WOLLONGONG LOCAL PLANNING PANEL ADDENDUM REPORT | 23 February 2024

DA No.	DA-2023/358
Proposal	Residential - demolition of existing dwellings and associated outbuildings, remove six (6) trees, construction of multi-dwelling housing - six (6) units and Subdivision - Strata title - six (6) lots
Property	11 and 13 St Johns Avenue MANGERTON
Applicant	Infinite Designs
Responsible Team	City Centre Major Development Team
Development cost	\$2,000,000
Lodgement date	3 May 2023
Prior WLPP meeting	5 December 2023

Assessment Report and Recommendation

PRIVATE OPEN SPACE SECTIONS

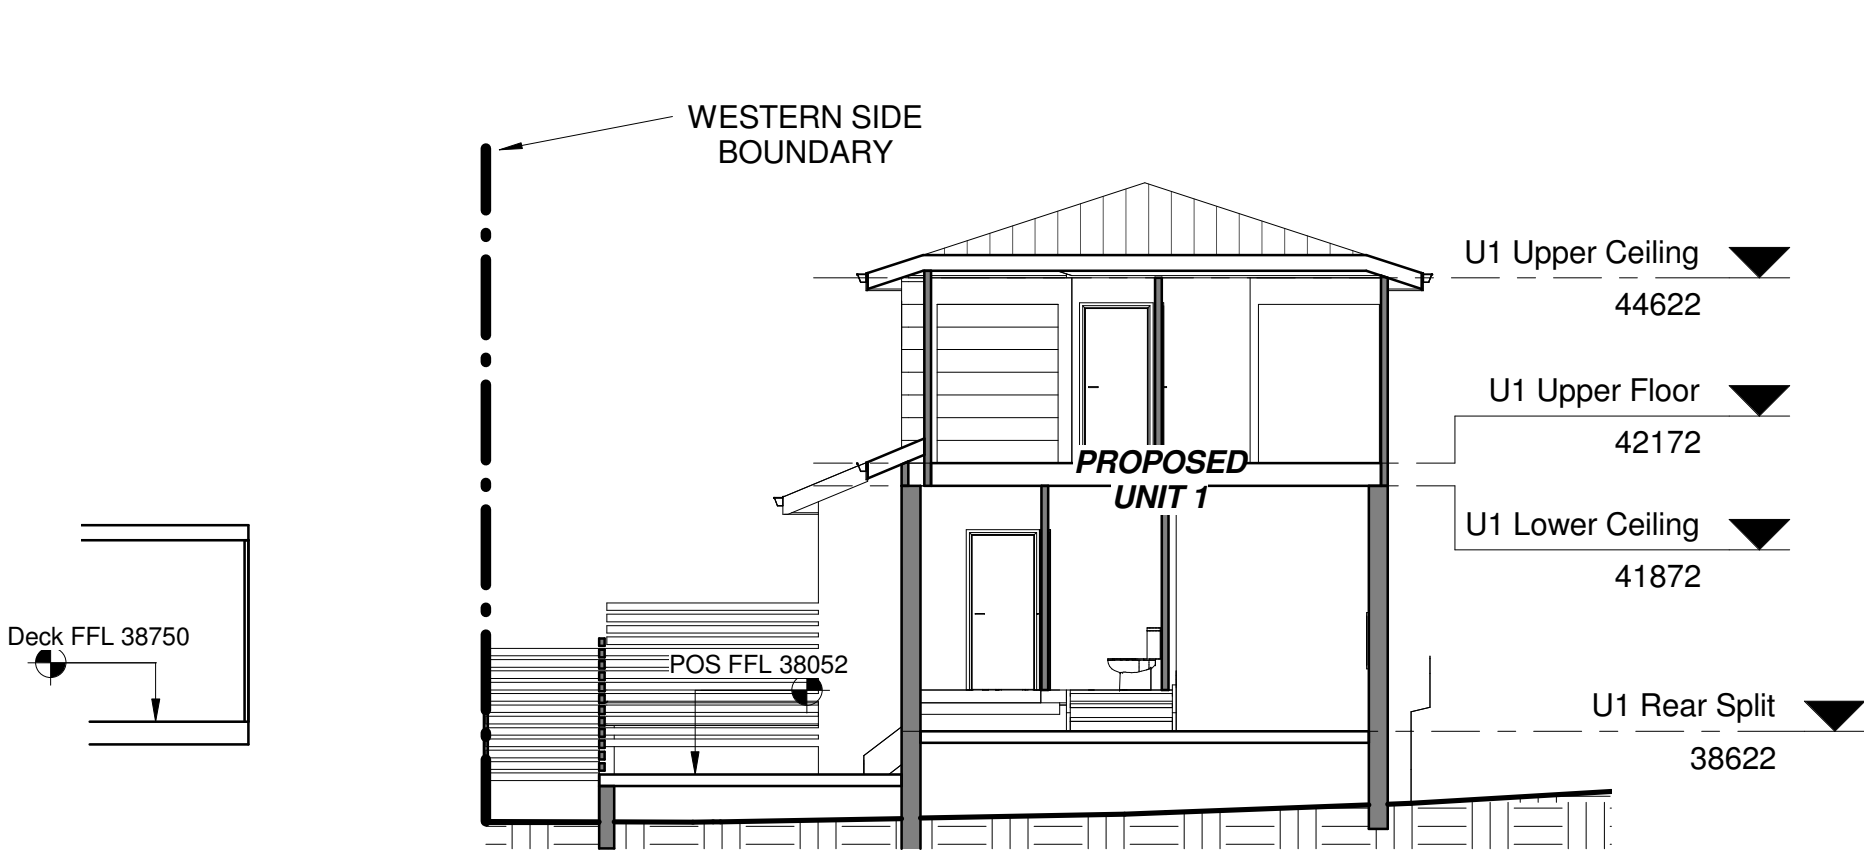
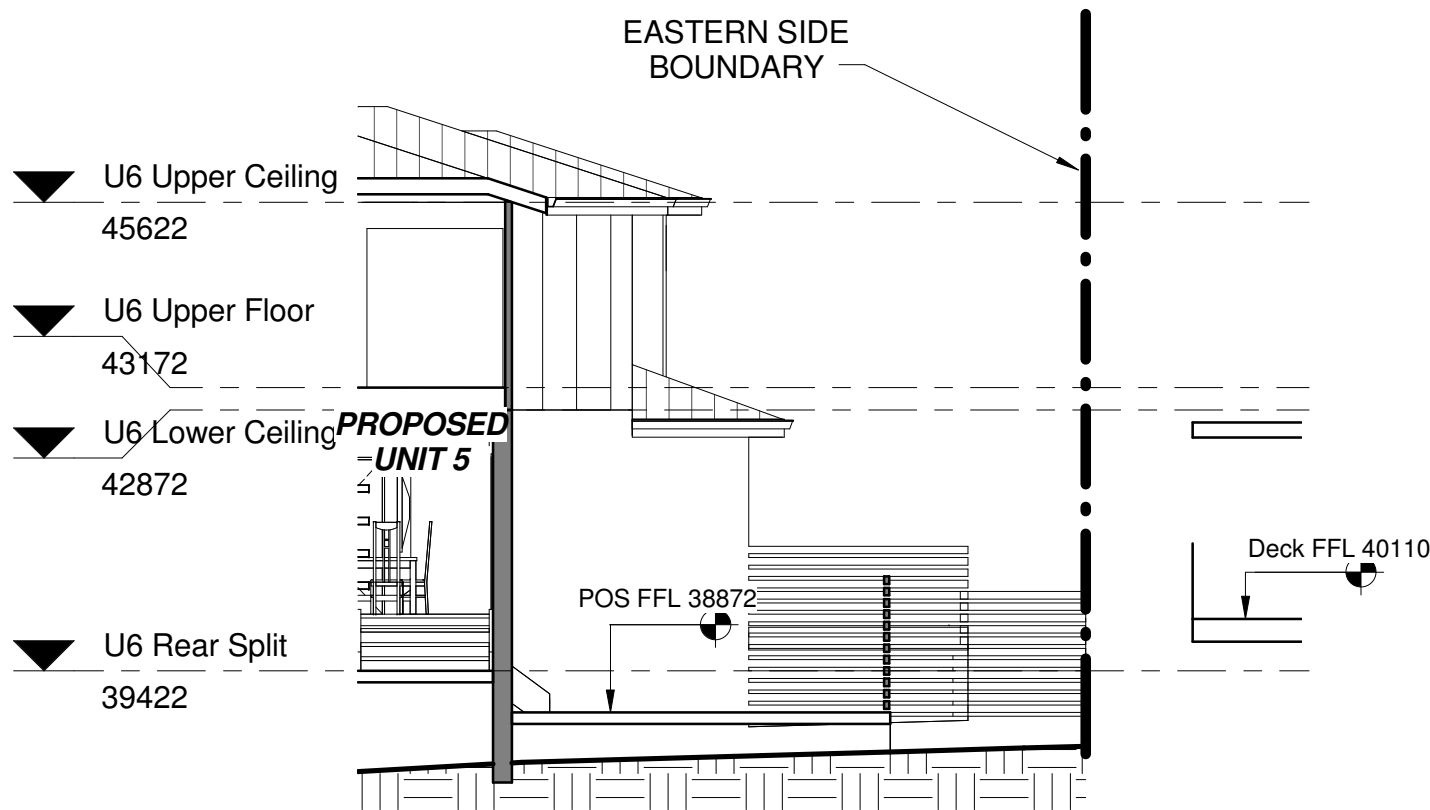
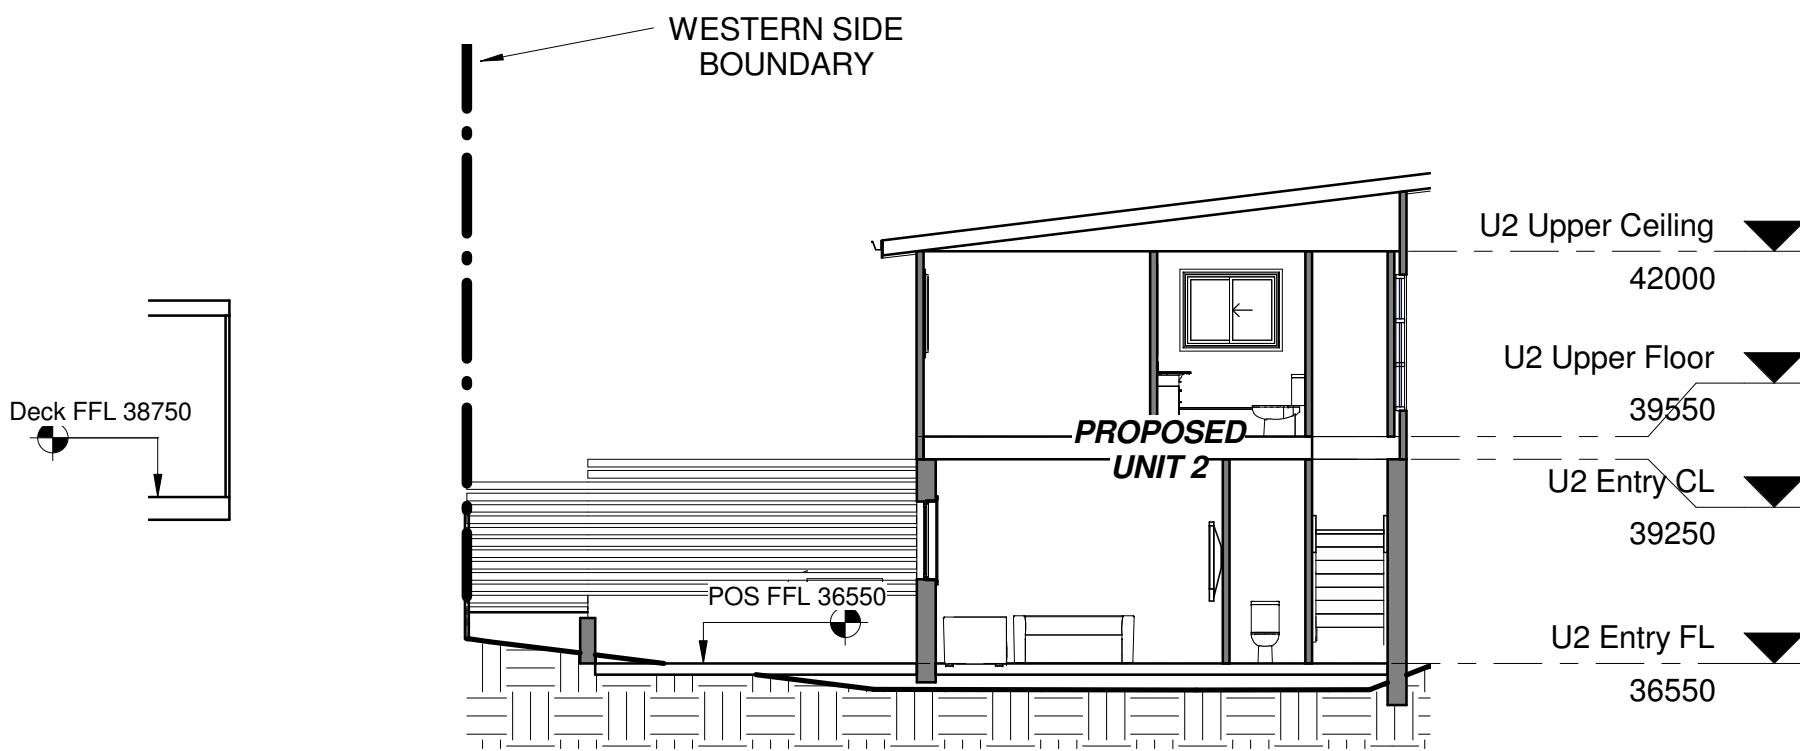
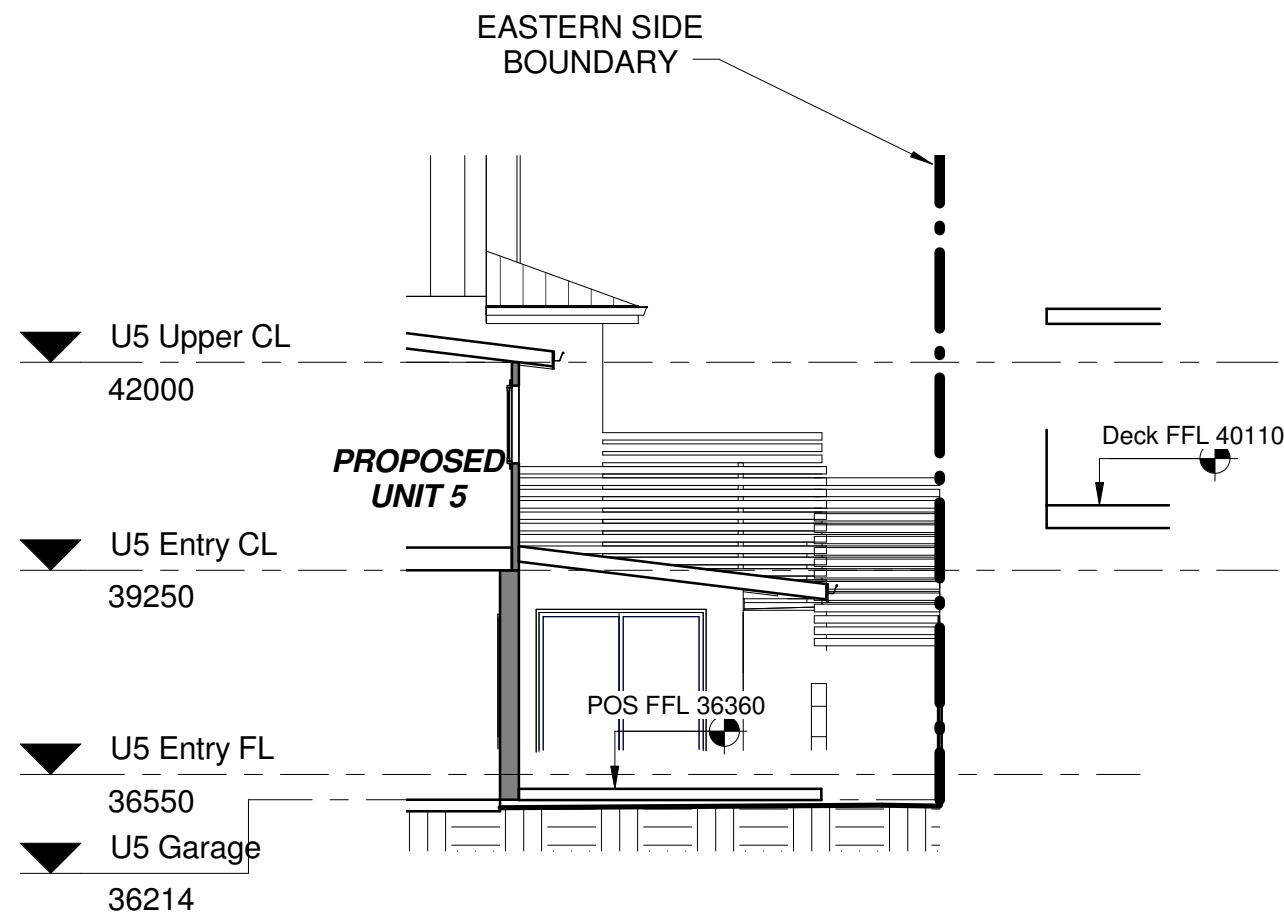
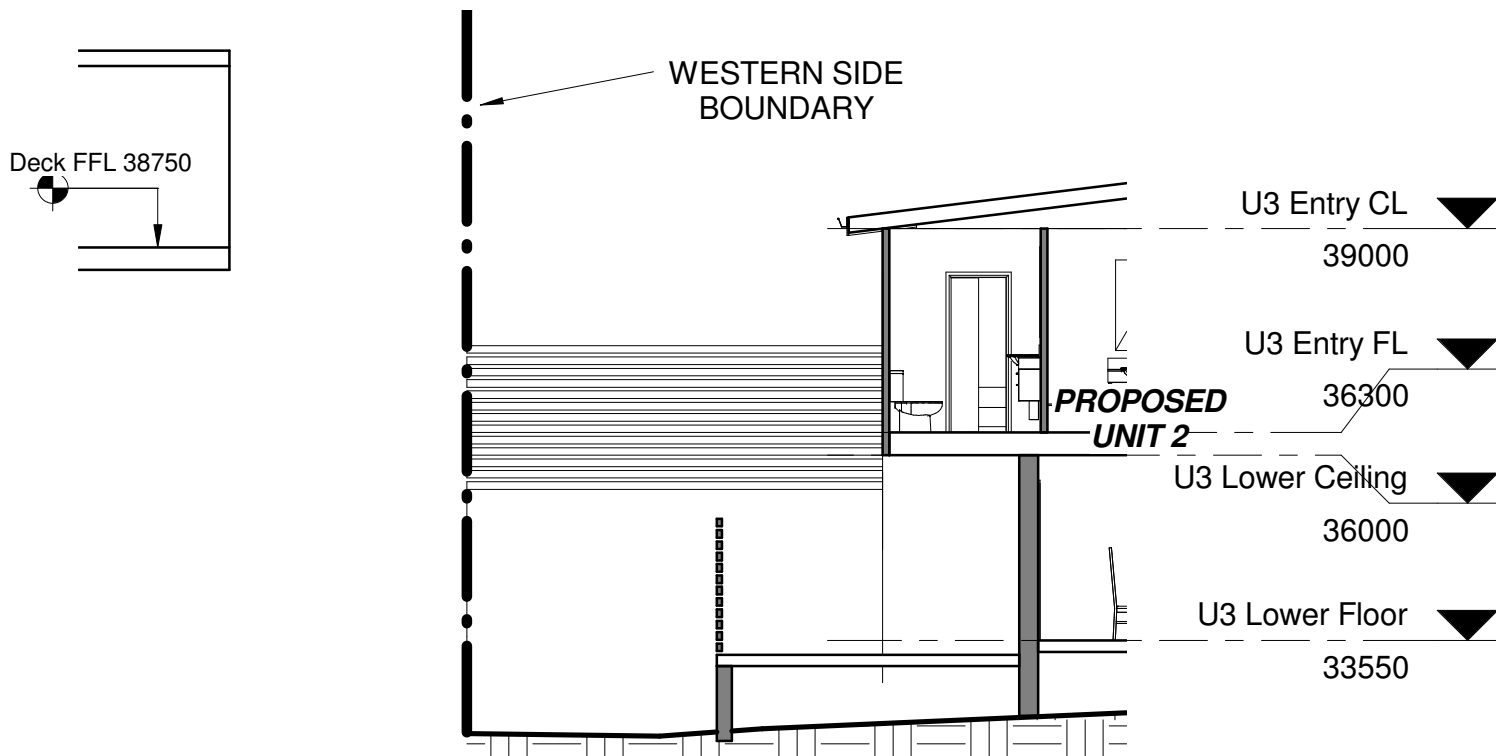
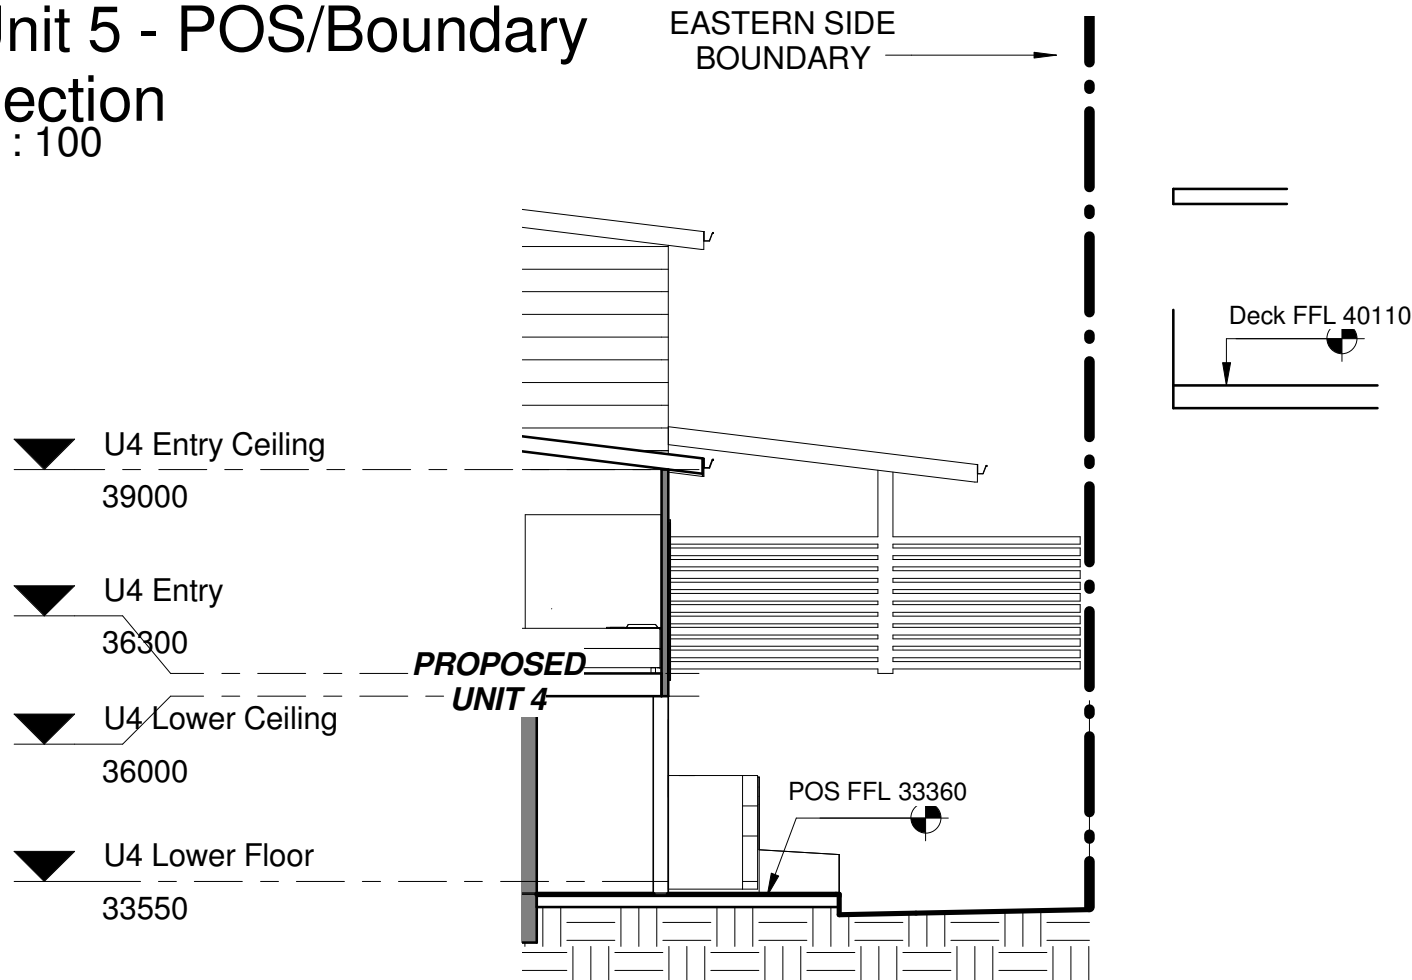
1. Cross-sections across side boundaries showing the relationship between the levels of private open space on the subject land and the levels of private open space areas/decks on adjoining property

2. Details of materials, finishes and height of any balustrades and privacy screens

Response: See plan A09a

Response: Balustrades are nominated to be powder coated aluminium (Plan reference A09a) and heights are stipulated on elevations (plan reference A07).

1 U1-U6 GROUND FL -
Setback Plan
1 : 100

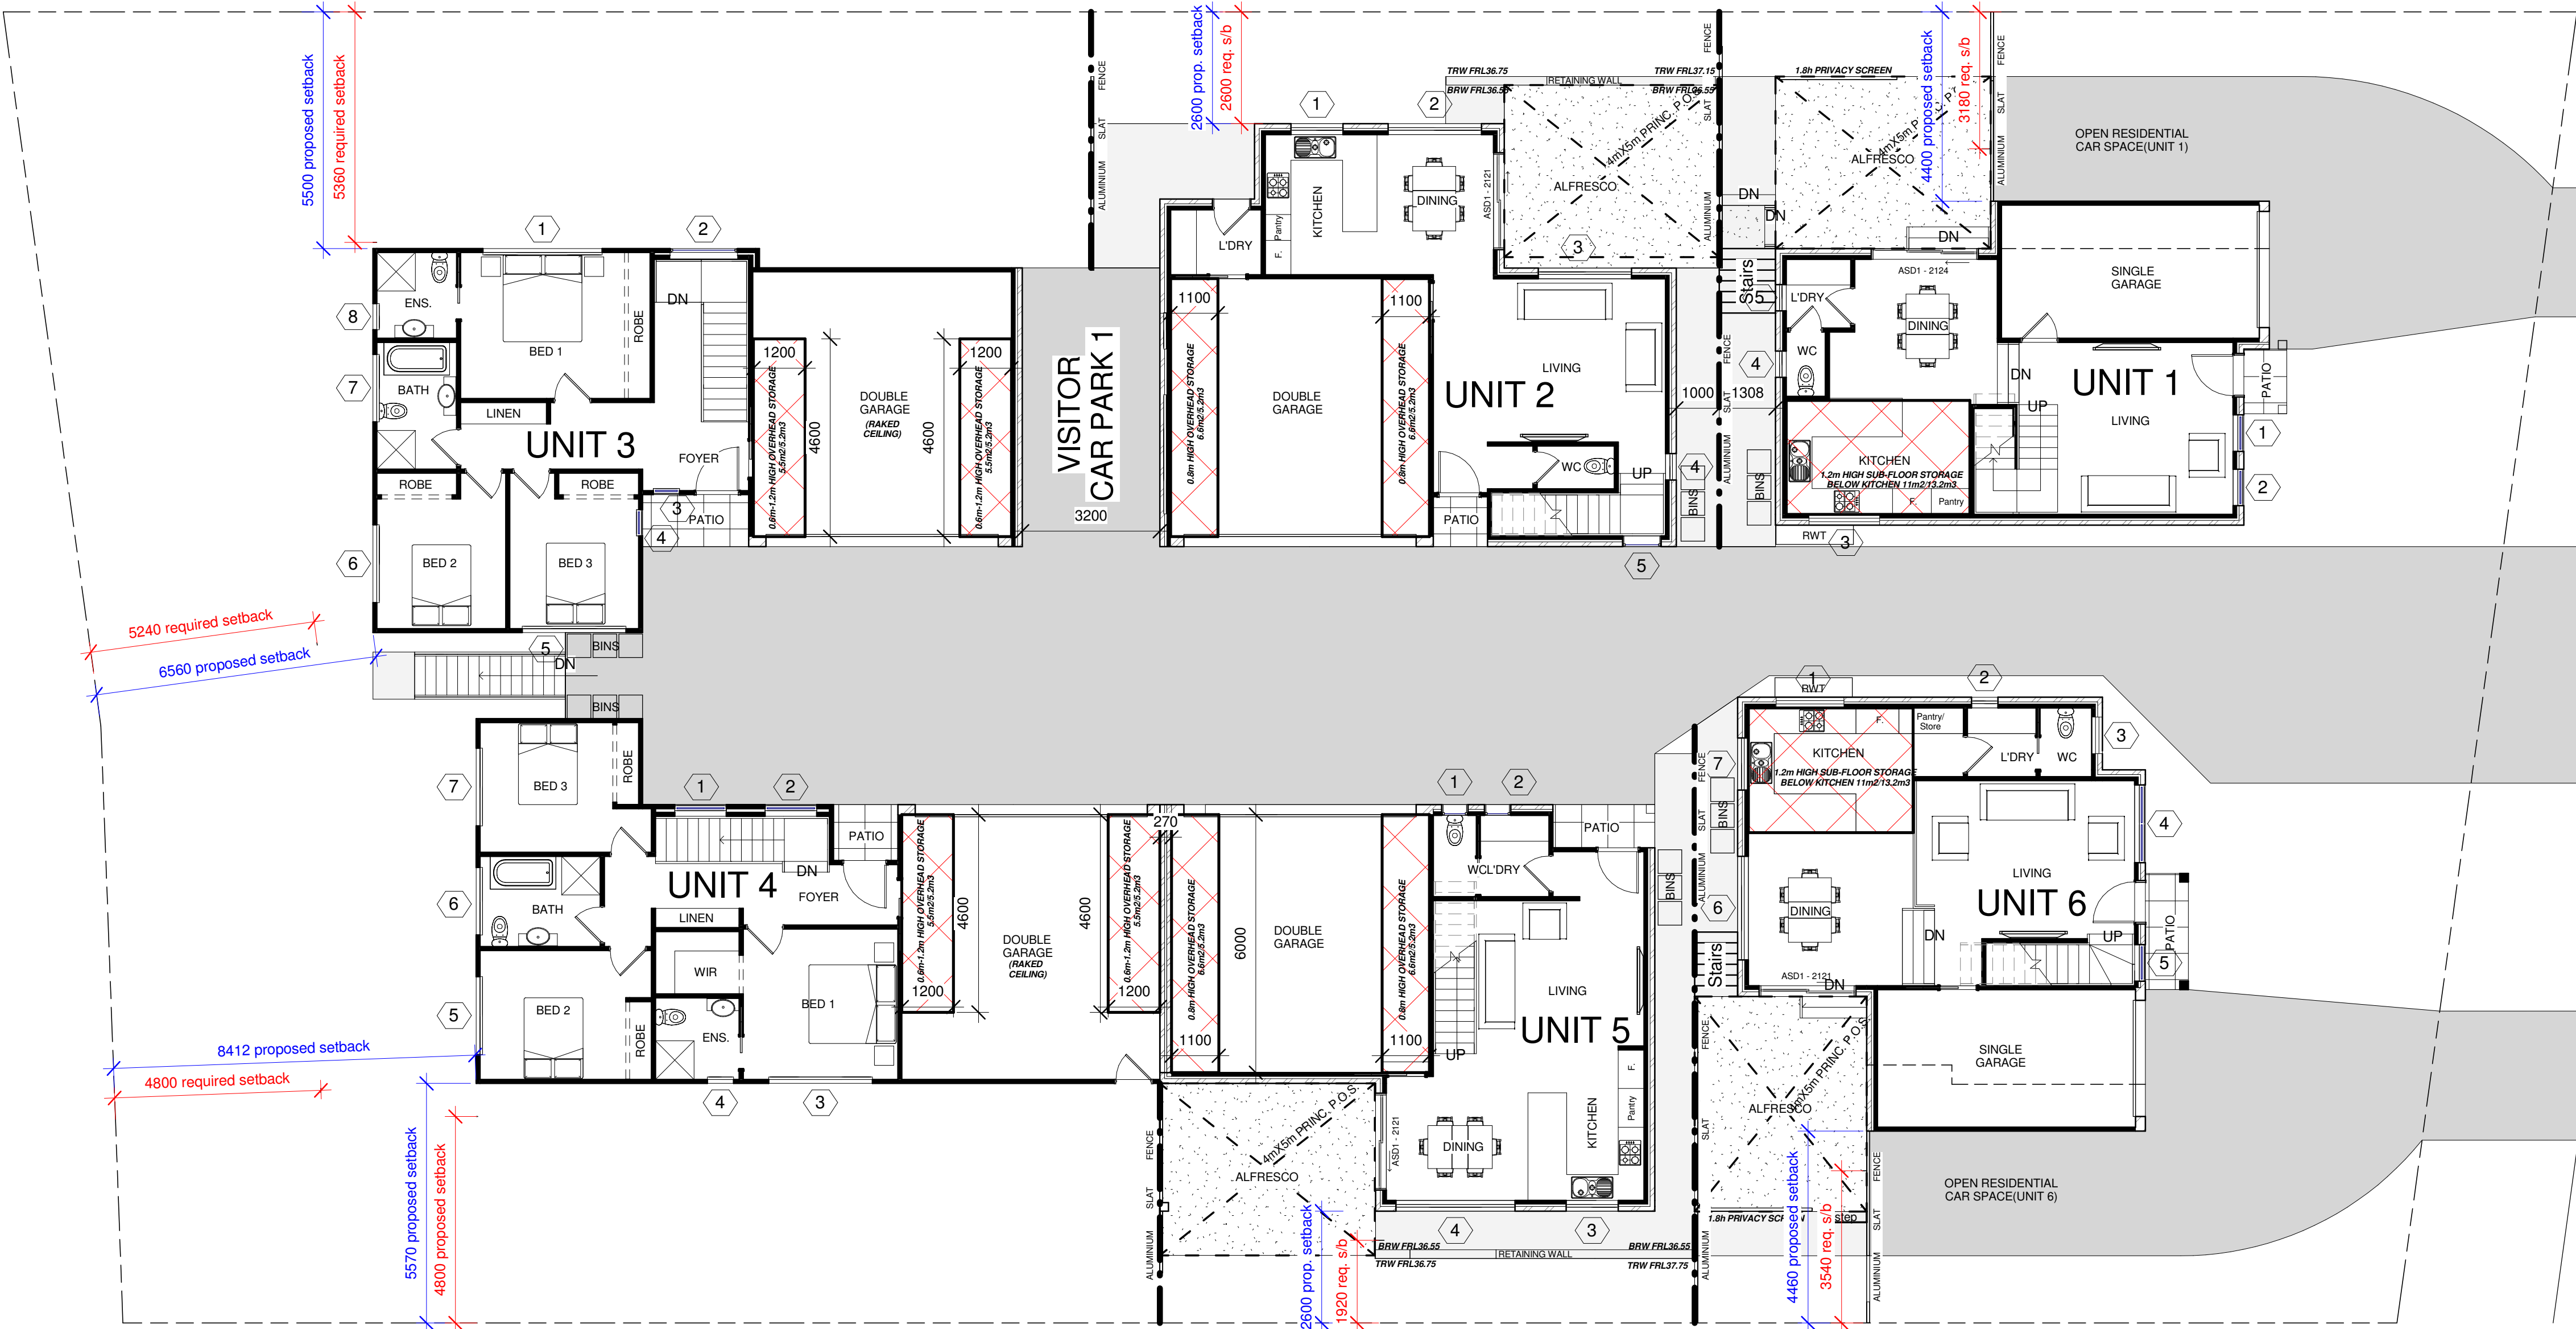
4. Side boundary setback dimensions for ground and first floor of all units to demonstrate compliance.

See marked up plans indicating proposed and required setbacks for units on Plans A09b and A09c.
